Rezoning Transportation Analysis

Petition Number: 2026-012

Date	Description
03-26-26	First Review (BH)

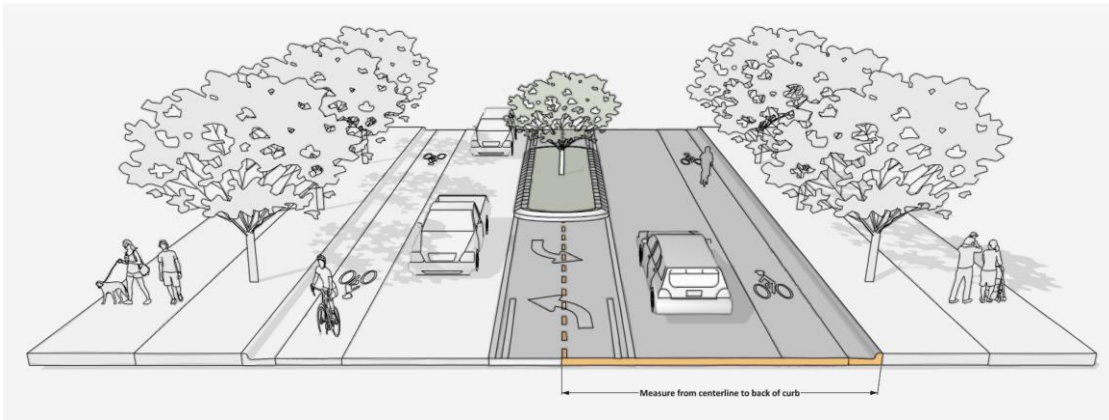
1. Curblines:

- a. **N Davidson St:** Location of future back of curb and gutter is to be shown at 24-feet from road centerline and must be shown in the future location according to UDO Article 32.7.

2+ Avenue with Bike Lanes (Charlotte Streets Map)

Label and dimension the existing and future curb and gutter form the centerline for each road on the site plan.

2+ Avenue with Buffered/Separated Bike Lanes (Charlotte Streets Map)

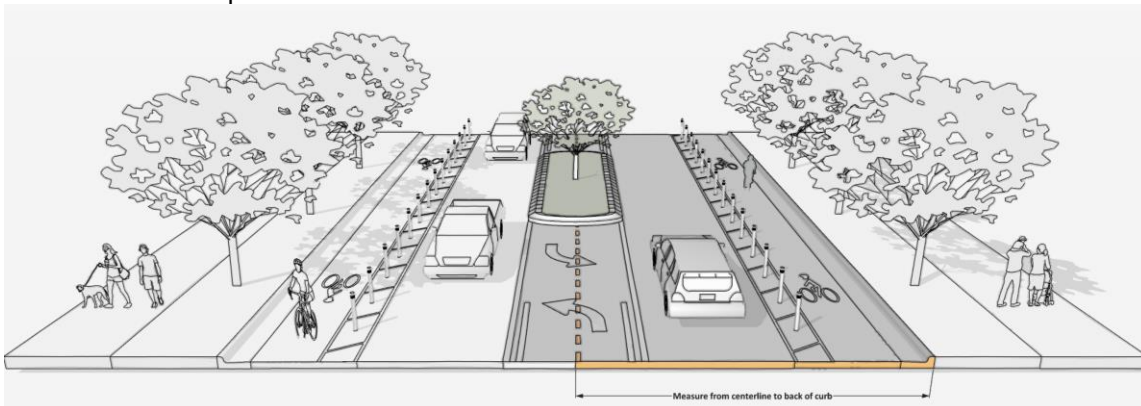
- b. **Parkwood Ave:** Location of future back of curb and gutter is to be shown at 27-feet from road centerline and must be shown in the future location according to UDO Article 32.7.

Label and dimension the existing and future curb and gutter form the centerline for each road on the site plan.

Collector Street (Charlotte Streets Map)

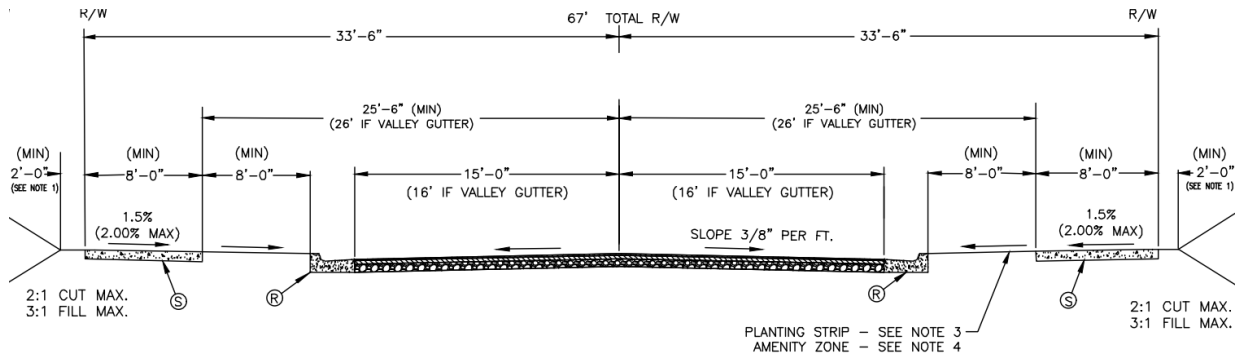
- c. **Belmont Ave:** Location of future back of curb and gutter is to be shown at 17.5-feet from road centerline and must be shown in the future location according to Charlotte Land Development Standards Manual (CLDSM).

Label and dimension the existing and future curb and gutter form the centerline for each road on the site plan.

Local Street (Charlotte Streets Map)

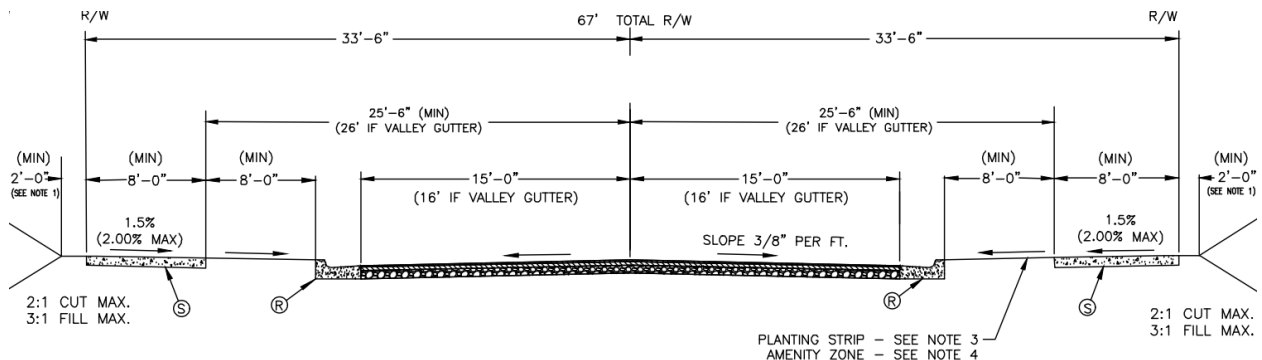
- d. **N Caldwell St:** Location of future back of curb and gutter is to be shown at 17.5-feet from road centerline and must be shown in the future location according to Charlotte Land Development Standards Manual (CLDSM).

Label and dimension the existing and future curb and gutter form the centerline for each road on the site plan.

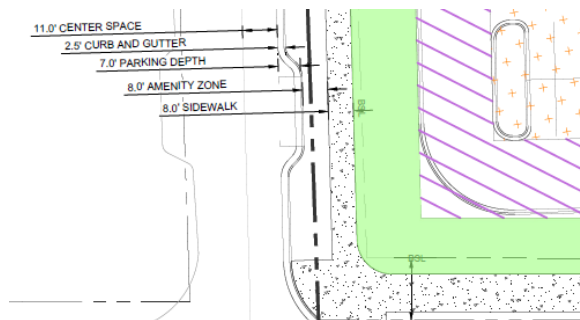
9. Revise site plan and conditional note(s) to remove the full access from N Davidson St.

10. Revise site plan and conditional note(s) to remove the proposed on-street parking space west of the proposed site access.
